IAG recommended modifications to the Framework plan and PDA: Comments by Theme

RE: Harvard Enterprise Research Campus (ERC), Master Plan for Planned Developed Area No. 115 and Framework Plan.

Feedback on Harvard's Master Plan for Planned Development (Area No. 115)

Figure 1. A conceptual sketch designed by CRWA in 2018 showing Green Infrastructure opportunities, including constructed wetlands and bioretention systems serving as a blue greenway, connecting Harvard ERC to the Charles River, I-90 Project area, and new parklands.

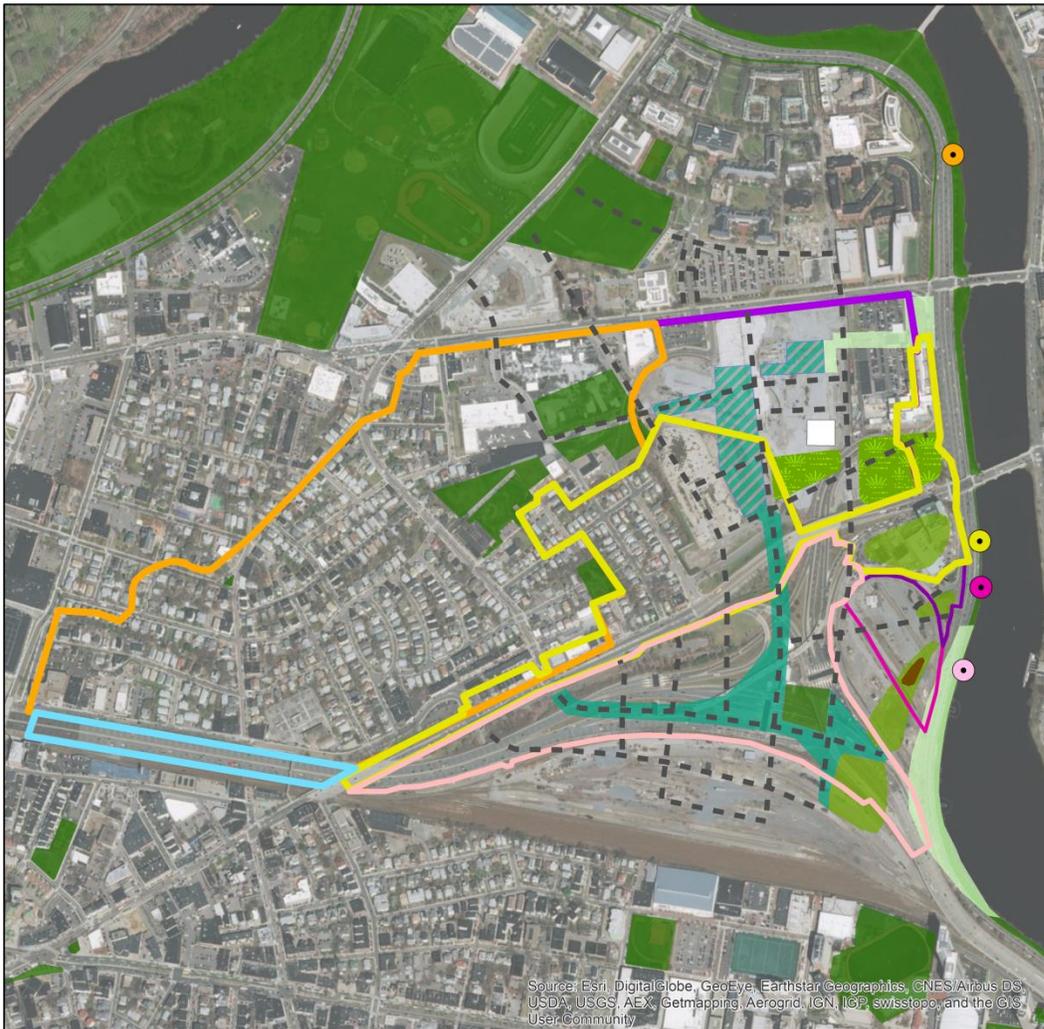
To show the feasibility of green infrastructure stormwater management CRWA has designed conceptual, connected bioretention systems that serve as a blue greenway system, sized to capture between 2"-5" of precipitation. The blue greenway(s) can be sited to connect the Harvard ERC project area to the Charles River as well as to the I-90 project area and new parkland proposed by MassDOT (see, Attachment A hereto).

CRWA has identified opportunities for Green Infrastructure (GI) in the Harvard ERC and designed conceptual systems to capture and manage a minimum of 2” and maximum 5” rain storm (Attachment A, Figure 1).

Figure 2. CRWA analysis showing major drainage areas where stormwater can be captured and managed by constructed wetlands and bioretention systems connected as a blue greenway.

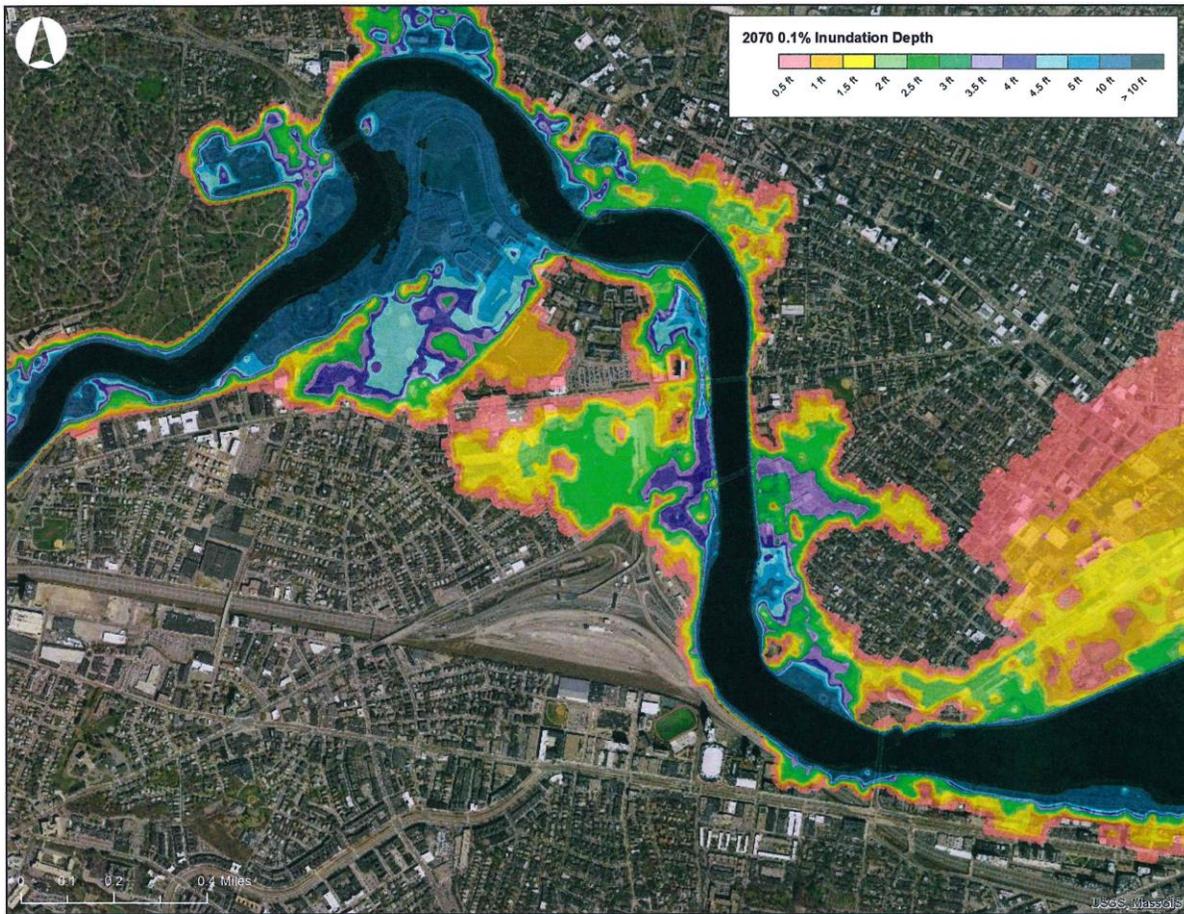
These GI designs will provide increased public open space, reduce flooding, and mitigate the Urban Heat Island effect while managing stormwater from drainage areas (Attachment A, Figure 2). We believe that this is precisely the kind of stormwater management that Harvard should be adopting in the face of predicted climate change impacts in the coming years.

Figure 3. MassDOT 0.1% flood inundation depth projections for the year 2070. Significant portions of the Harvard ERC project area are shown to be up to 2-4 ft under water.

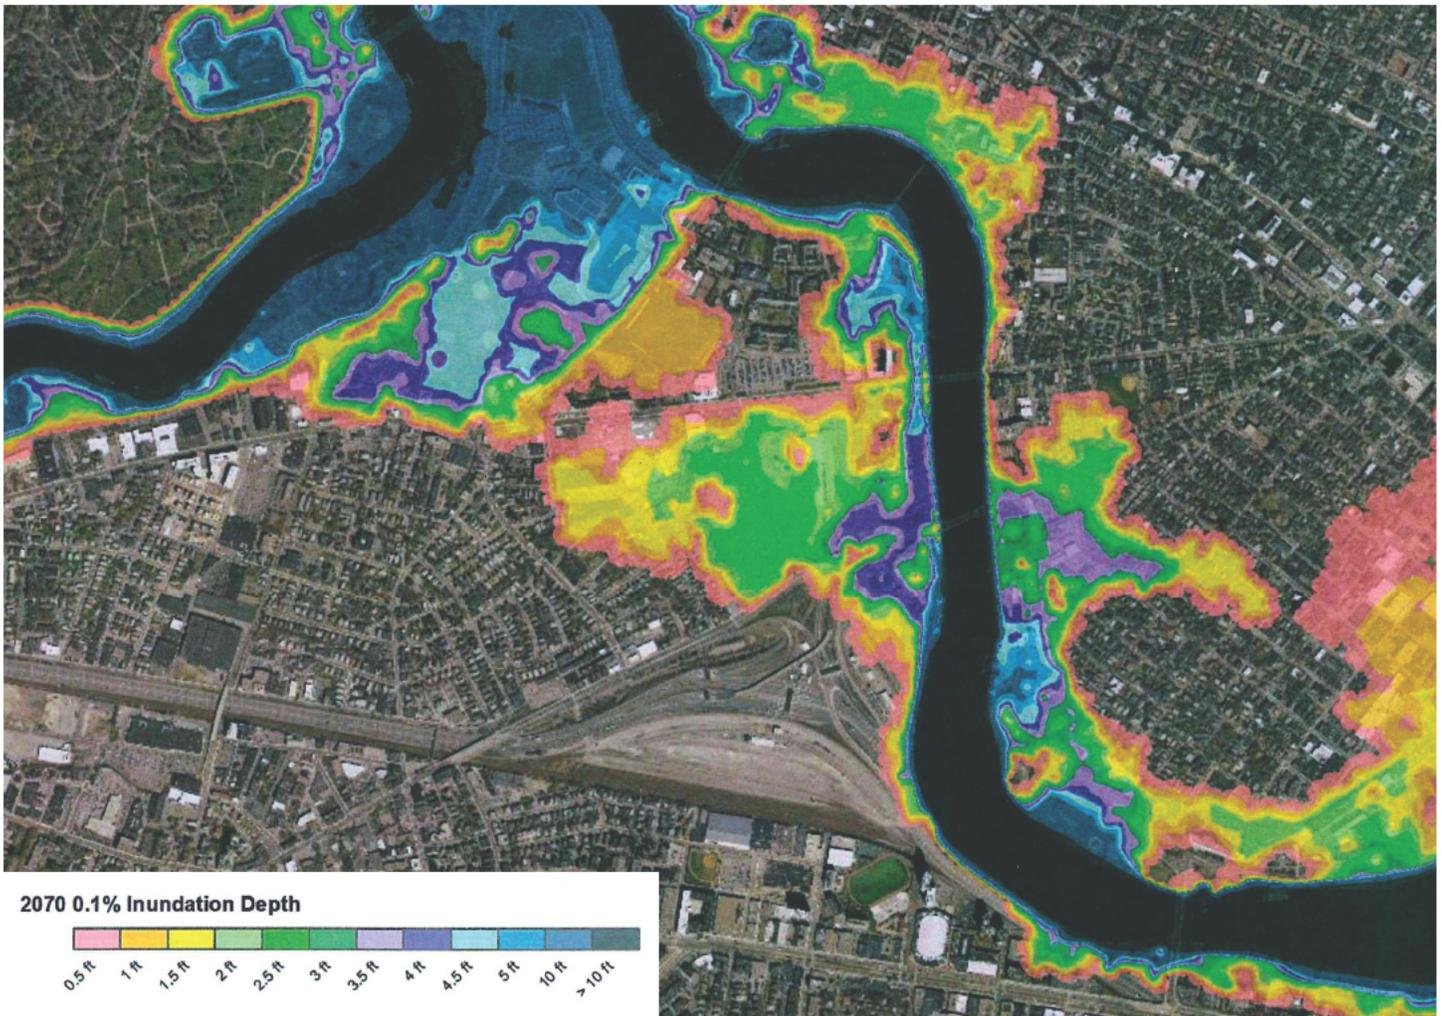
As shown in Attachment A, Figure 3, the project is located in an extremely flood-prone area.⁶ Historically, sections of the IMP and the ERC PDA sites both north and south of Western Avenue were low-lying tidal marshlands that were filled in to support development. In order to build capacity for current and increased flooding, the proponent should not only document the alteration of historic site hydrology, but also try to restore or mimic it through the establishment of a series of blue greenways and green infrastructure retrofits (bioswales, infiltration basins, etc.).
